Development Review Committee
February 11, 2026
1776 INDEPENDENCE LANE, MAITLAND ,
FL 32751
2:00 PM

**SPR(2024)-0073 -801 S Lake Destiny Road
DEVELOPMENT REVIEW COMMITTEE
FEBRUARY 11, 2026**

EXHIBIT A

Revisions Remaining from TRG Report:

Site Plan

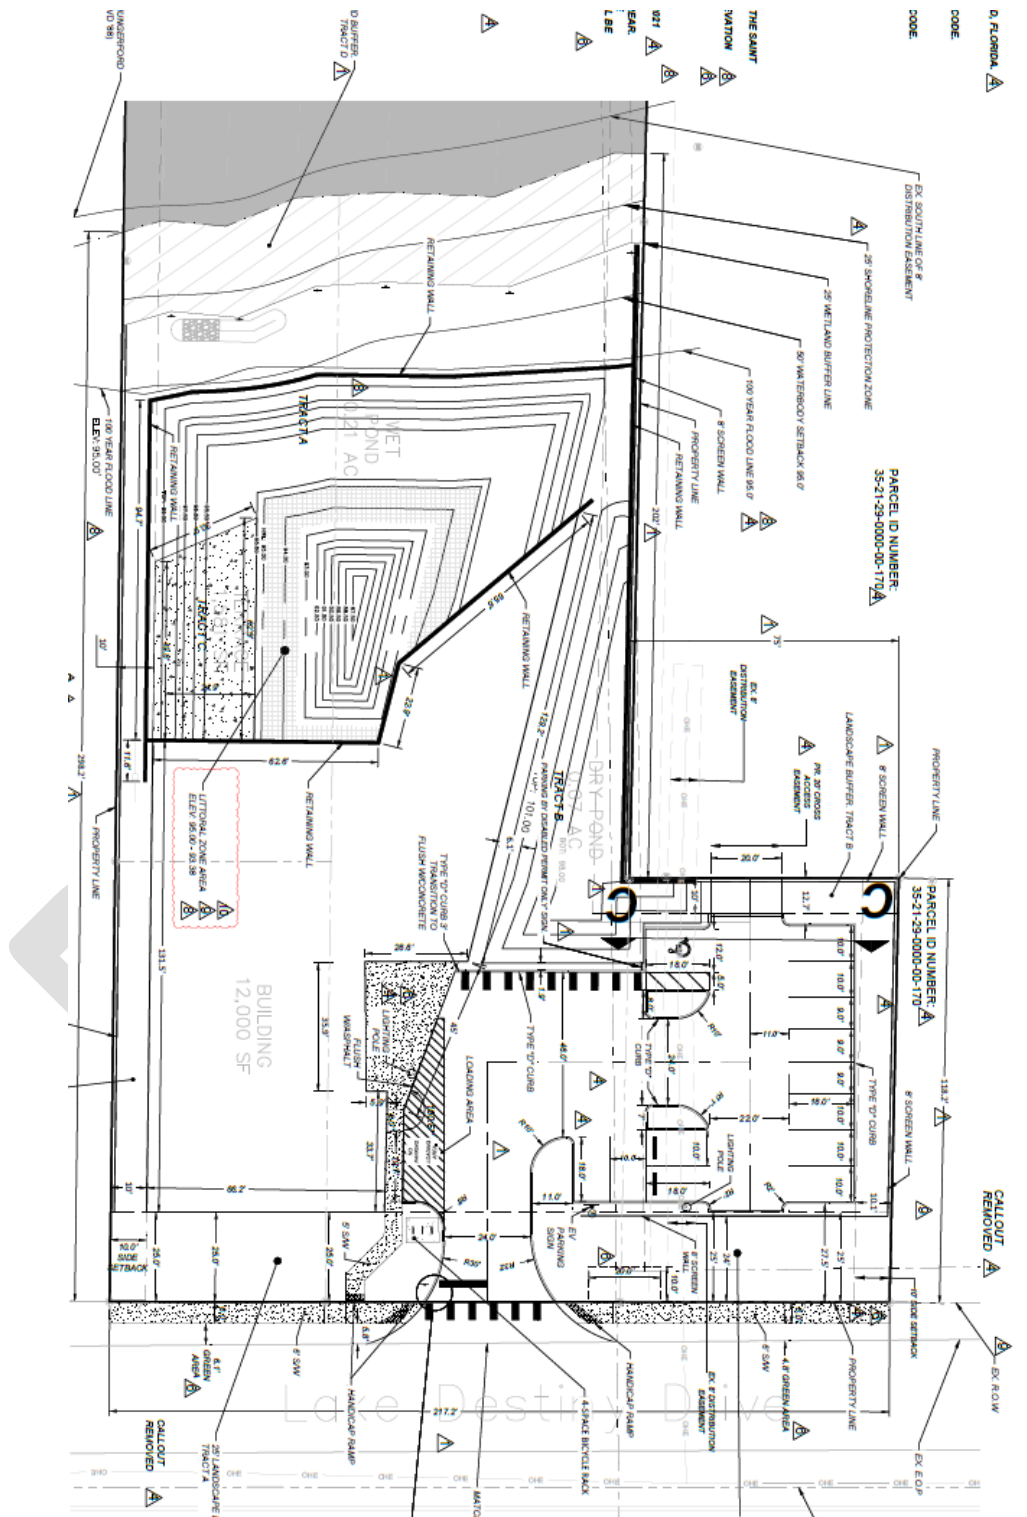
1. Name of plans on Index must be consistent with the names on each sheet. **Comment not addressed 1.10.25** The title for Sheet 8 does not match the index sheet. **Comment not addressed 03.19.25** Sheet T-100 is still not properly matching the index. **Comment not addressed 07.15.2025** The survey and utility designation included in the set is not located in the proper order in the index. Also, a photometric plan was not included in the set. Please revise. **Comment not addressed 10.2.2025** The Photometric plan contains two sheets, however only one is listed on the cover page. **Comment not addressed 1.14.26.** (Building Permit revision)

2. The site plan must identify the NHWE of Lake Hungerford and the 25' shoreline protection zone that is measured from the NHWE. **The NHWE is incorrect per the Maitland Land Development code. Setbacks must then be from correct NHWE line. Comment not addressed 1.10.25** The NHWE is still incorrect per the land development code. Please see section 5.3.7 of the land development code. **Comment not addressed 03.19.25** While the NHWE has been listed as well as the 25' wetland protection zone, the protection zone lists an elevation of 95' that doesn't match the 95' flood elevation. Please clarify. **Comment not addressed 07.15.2025** While the wetland protection zone is shown, it still has an incorrect elevation listed. The zone is not based on an elevation, but rather a distance. Please revise or clarify. **Comment not addressed 10.2.25** Wetland protection line is still displaying an incorrect elevation. **Comment not addressed 1.14.2026.**

3. Plan must show the 100-year flood line. It appears that the current plan may be proposing impacts within the 100 year flood plain. Any fill placed below the 100 year base flood elevation must provide compensating storage. If there are impacts please provide the appropriate calculations. **Comment not addressed. 1.10.25** The 100 year flood line is displayed but does not included the elevation for verification. Please see section 5.3.7 of the land development code. Compensating storage calculations are shown in the report but no location or required volume are given for the compensating storage. Please show the area this is meant to be located in order to verify as well as provide the required volume. **Comment not addressed 03.19.25** Floodplain compensation has to be hydraulically connected below the 100-year elevation. As shown, this connection does not exist. Additionally, the compensation volume must be below the 100 year volume, which also is not present as shown. Lastly, the city does not allow for floodplain compensation to be provided interior to stormwater retention areas. This will be required to be in a separate area with the sole purpose of floodplain compensation. Revise plans accordingly. **Comment not addressed 07.15.2025.** The claim that compensating storage outside of the pond is not feasible is incorrect, as this is new development with no constraints. The only element constraining the compensating storage is the building size.

As previously stated, the city does not allow compensating storage within the stormwater pond. Additionally, the statement that the stormwater pond is hydraulically connected below the 100-year flood is inaccurate. The orifice is set equal to the 100-year flood, and not below. Secondly, due to the very small size of a typical orifice, an orifice alone is not generally considered to be hydraulically connected. Please revise or clarify. Comment not addressed 9.29.25 There is a wall callout that does not appear to point to the wall, and shows a 95.10 elevation directly next to the flood hazard zone. All grading callouts should be at the wall, at or above the flood line. Comment not addressed. 1.14.2026

4. Provide the utility calculations. Utility calcs not provided 1.10.25 Provide the calculation for the sanitary demand of 1480 gpd ADF Comment not addressed. 03.19.25 It is not clear the calculation is in conformance with Section 4.2. Flow demands are based on OCU Standards and Construction Specification Manual Appendix E. The flow rates listed do not appear to match appendix E. Utility report not signed and sealed. Revise accordingly. Comment not addressed 07.15.2025 Utility Demand calculations does not match SF of plan. Revise to be consistent and any other associated documentation based on that. Comment Not addressed 10.2.25 The sanitary sewer portion of the utility calculations provides demand for a total 13,200 sq ft which is different from the potable demand building sq ft used and sq ft on the plans. Comment not addressed. 1.20.26.

5. Plans list CS-1 top as 101, while calculations list it as 100. 100 is also used in the ICPR calculations. Similarly, the plans show a different top elevation for CS-2 than what are used in the calculations. Please revise accordingly 1.10.25 While the listed elevation in the structure data has been revised to match the report, there are still elevation callouts for each overflow structure that do not match the listed top of structure (cs1 is called out at 101, cs2 at 102) Comment not addressed 03.19.25 Per the report, the weir for pond 2 is to be set at 100' (page 54). The plan set shows it at 98' please clarify. The detail for the structure also shows top of structure as 101.5'. CS-2 callout on sheet 8 is still incorrect top elevation. Comment not addressed 07.15.2025 Response comment letter states pond 2 to be 99.5, plan shows 98.5 Revise accordingly. Comment not addressed 10.2.25. Pipe size into CS-2 not consistent between plans and report. Please revise. Comment not addressed. 1.14.2026
